PD15-002a

ITB16-007a

January 28, 2016

## JX35, QX60 AND QX60 HYBRID; REVISED REAR FINAL DRIVE ASSEMBLY SPECIFICATION

Figure 1

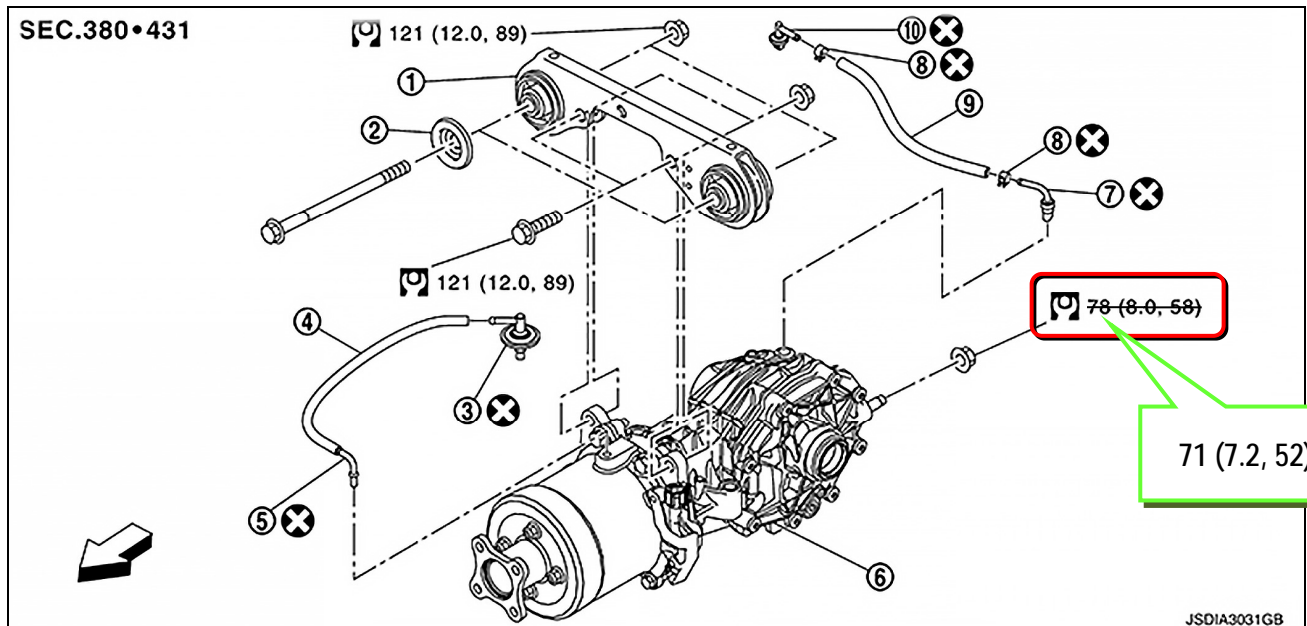
On Applied Vehicles, the torque specification for the rear final drive assembly rear mounting stud has been revised.

**New torque specification: 71 N-m, 7.2 kg-m, 52 ft-lbs**

Use the torque specification shown above when installing a rear final drive assembly.
